CONSTRUCTION PLANS FOR PRIVATE SANITARY SEWER EXTENSION TO SERVE PART OF LOT 1, BLOCK 2, MID-CONTINENT AIRPORT ADDITION (BALLARD AVIATION)

IN
THE CITY OF WICHITA,
SEDGWICK COUNTY, KANSAS
MICHAEL E. LINDEBAK, P.E.- CITY ENGINEER
PRIVATE PROJECT NO. 892 PPS (607861)

RECORD DRAWING

Michael E. Lindebak
APPROVED AS NOTED
By CITY ENGINEER OF WICHITA

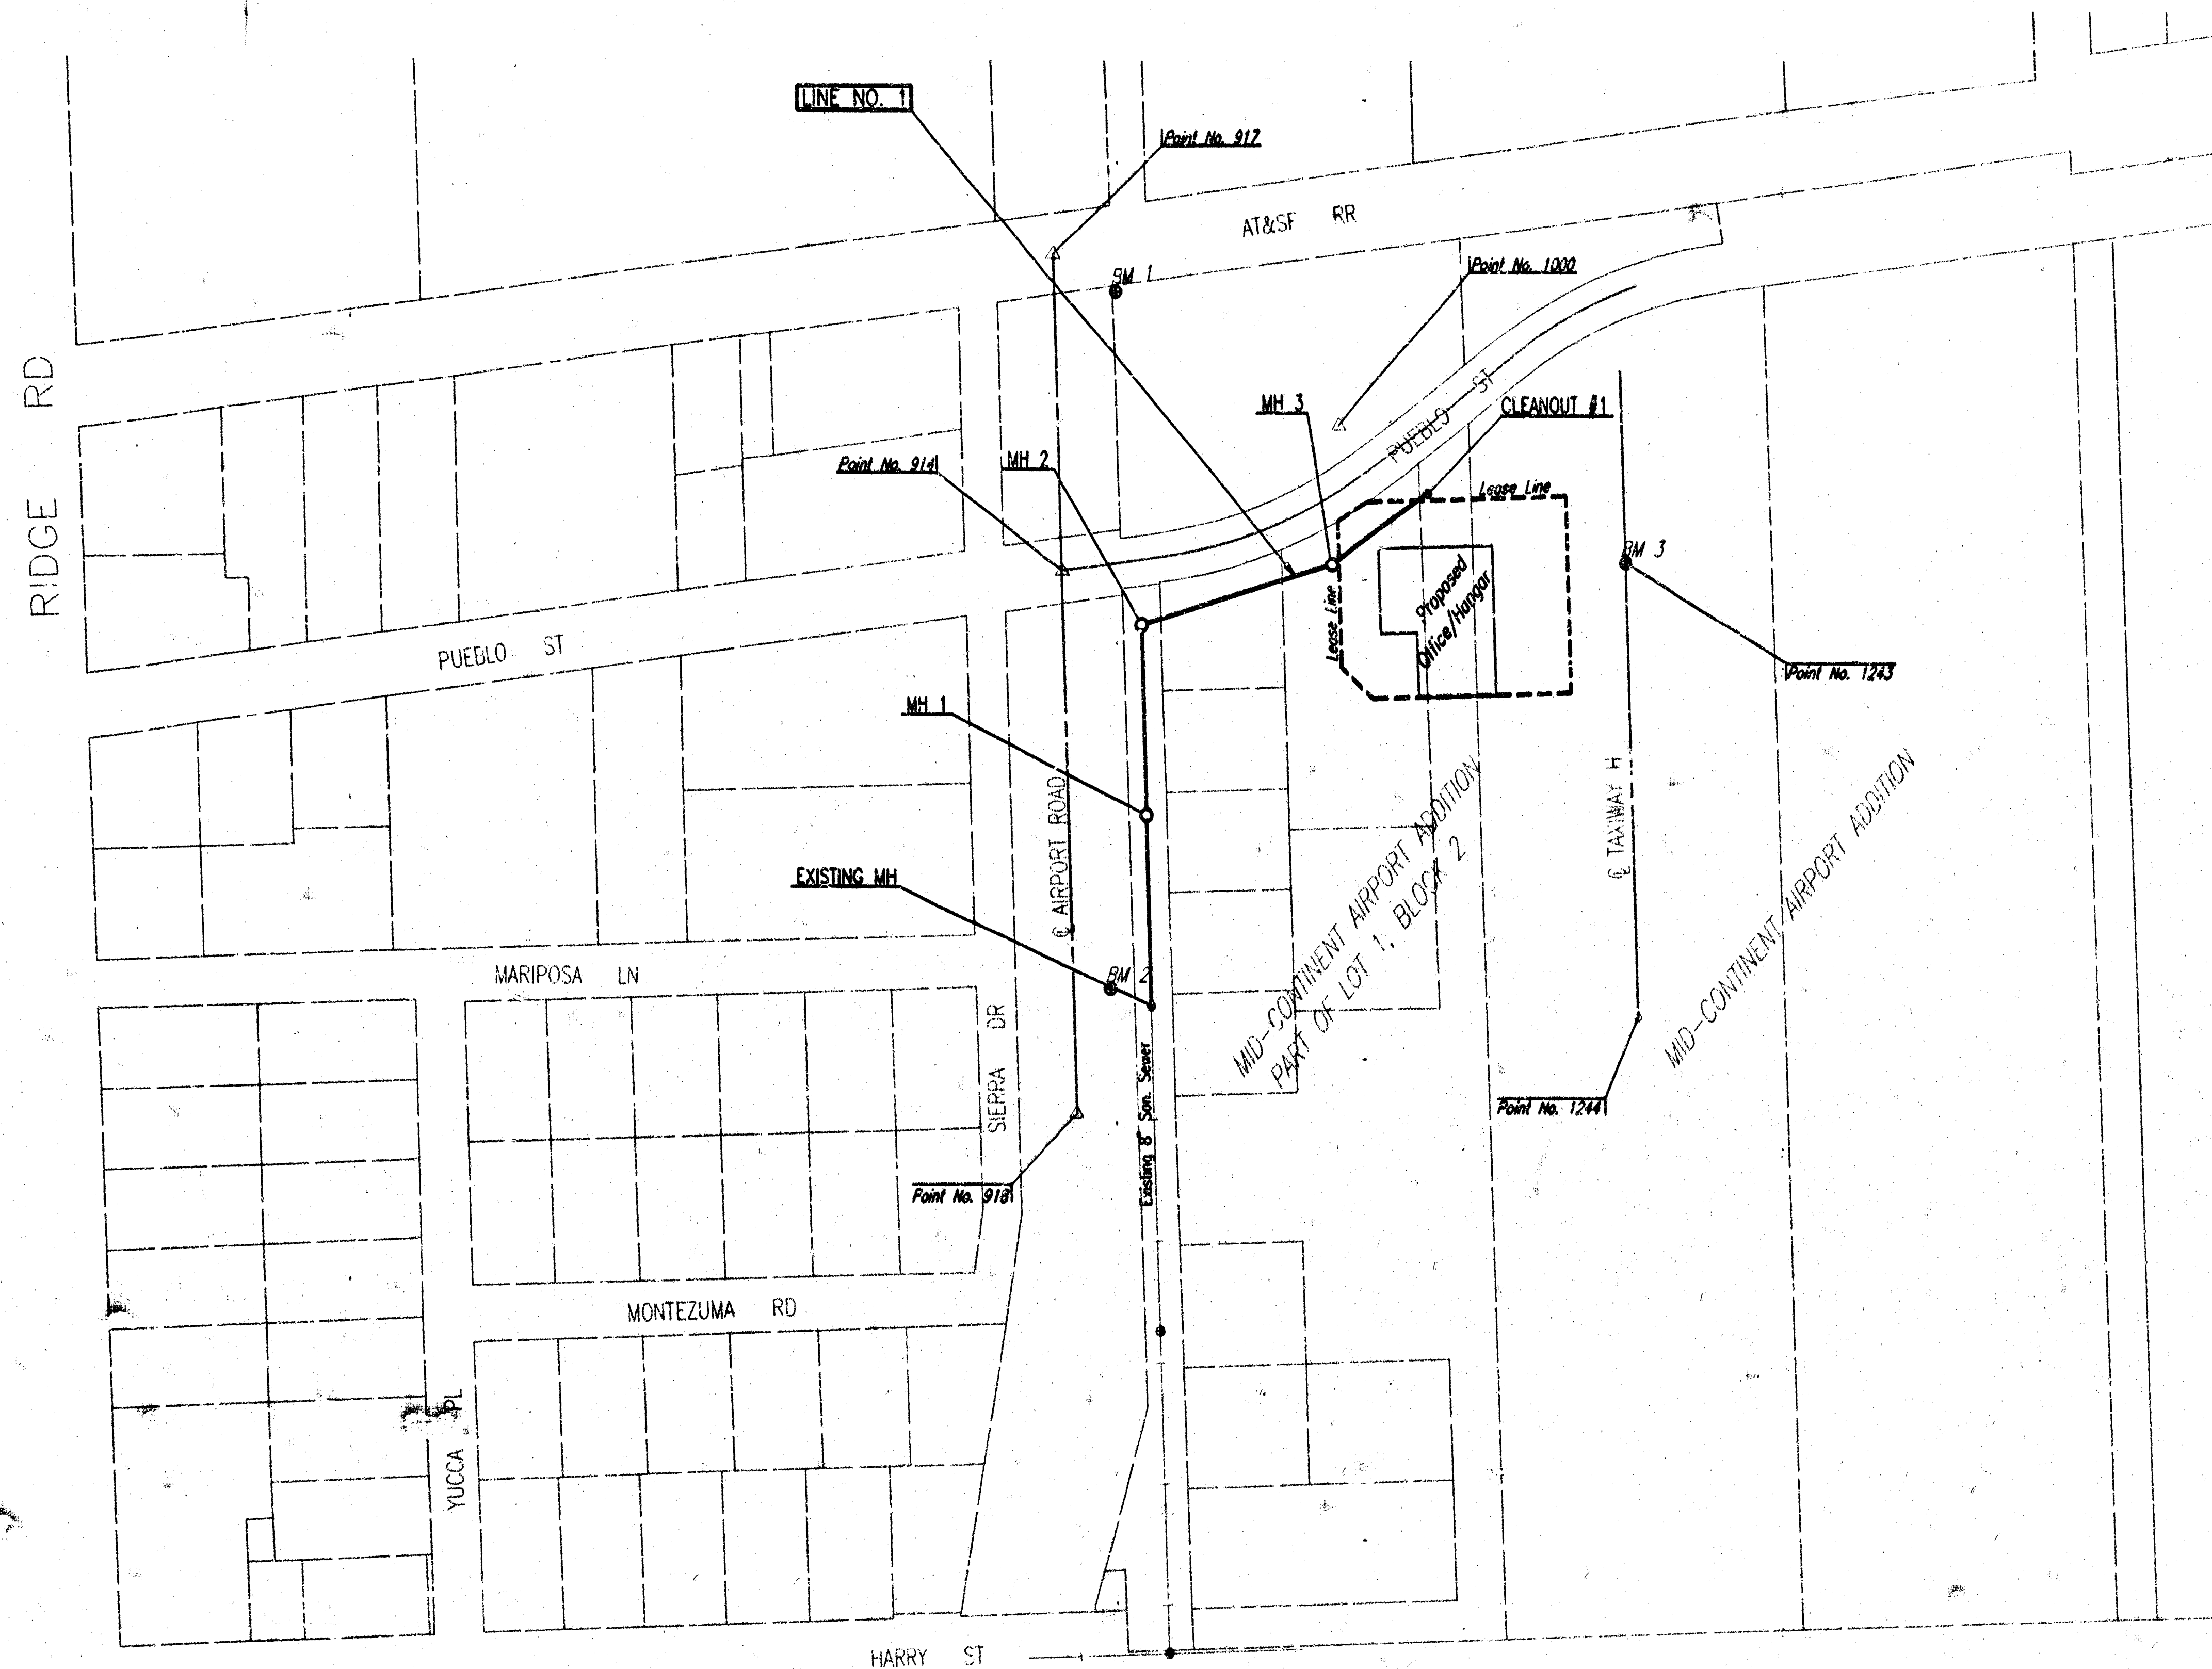
- ~~ALL LAWN/TURF AREAS DISTURBED BY CONSTRUCTION OF THE PROPOSED IMPROVEMENTS SHALL BE RESTORED WITH THE SAME GRASS/GRAPE EXISTING. RESTORATION OF DISTURBED AREAS SHALL INCLUDE, BUT NOT BE LIMITED TO, TOP SOIL PREPARATION, SEEDING, MULCH, AND/OR RESEEDING. ALL SEEDING AND MULCHING WORK SHALL BE IN ACCORDANCE WITH THE CITY OF WICHITA STANDARD SPECIFICATIONS AND THE CITY OF WICHITA ADMINISTRATIVE REGULATION NO. AR78 WHICH GOVERNS CLEANUP AND RESTORATION OR REPLACEMENT FOLLOWING CONSTRUCTION. ALL COSTS FOR THIS WORK SHALL BE SUBSIDIARY TO THE LUMP SUM PRICE BID FOR "SITE RESTORATION".~~

- ~~RUBBLE FROM THE REMOVAL OF MISCELLANEOUS STRUCTURES INCLUDING ANY TREES REMOVED, TREE TRIMMINGS, AND EXCESS EXCAVATION WHICH IS TO BE WASTED SHALL BE DISPOSED OF ON SITES PROVIDED BY THE CONTRACTOR. THESE SITES SHALL ALSO BE APPROVED BY THE ENGINEER AS TO SUITABILITY, APPEARANCE, AND SITE LOCATION. LOCATIONS THAT, IN THE OPINION OF THE ENGINEER, WILL LEAVE AN UNDESIRABLE APPEARANCE WILL NOT BE APPROVED. ALL DISPOSAL SITES MUST BE APPROVED BY THE KANSAS DEPARTMENT OF HEALTH AND ENVIRONMENT. MATERIAL EITHER STOCKPILED OR DISPOSED OF IN A FLOOD PLAIN WILL REQUIRE A KANSAS STATE BOARD OF AGRICULTURE PERMIT. ANY MATERIAL DUMPED IN WATERS OF THE UNITED STATES OR WETLANDS IS SUBJECT TO U.S. CORPS OF ENGINEERS PERMITTING REGULATIONS. ANY MATERIAL BURIED OR STOCKPILED BEYOND APPROVED CONSTRUCTION LIMITS MAY REQUIRE ARCHAEOLOGICAL INVESTIGATIONS UNLESS BURIED IN A PREVIOUSLY APPROVED DISPOSAL LOCATION.~~

- CONTRACTOR IS REQUIRED TO MAINTAIN CONTINUOUS FLOW OF SEWAGE IN EXISTING MAINS AT ALL TIMES.
- ~~THE CONTRACTOR SHALL SEED ALL AREAS DISTURBED BY CONSTRUCTION ACTIVITIES WITH A MINIMUM OF ONE (1) POUND PER ONE THOUSAND (1,000) SQUARE FEET. THIS TEMPORARY SEEDING MAY BE OMITTED ONLY IF OTHER SEEDING IS REQUIRED IN ACCORDANCE WITH GENERAL NOTE NO. 9 ABOVE. TEMPORARY SEEDING OR PERMANENT SEEDING/SODDING SHALL BE APPLIED WITHIN 14 DAYS AFTER THE AREA HAS BEEN DISTURBED.~~

- ~~EXISTING GROUND LINE AS SHOWN ON THE PLANS IS FROM A FIELD SURVEY PERFORMED OCTOBER 1998. GRADING OPERATIONS HAVE OCCURRED SINCE THE FIELD SURVEY AND ARE NOT REFLECTED IN THESE PLANS. THE CONTRACTOR SHOULD BE AWARE THAT THIS GRADING WORK MAY AFFECT THE EXCAVATION DEPTH OF THE PROPOSED SANITARY SEWER. THE CONTRACTOR SHALL CONFIRM THE PROPOSED MH TOP ELEVATIONS WITH THE OWNER AT TIME OF CONSTRUCTION. ALL WORK MENTIONED HEREIN SHALL BE PERFORMED AT NO ADDITIONAL COST TO THE OWNER.~~
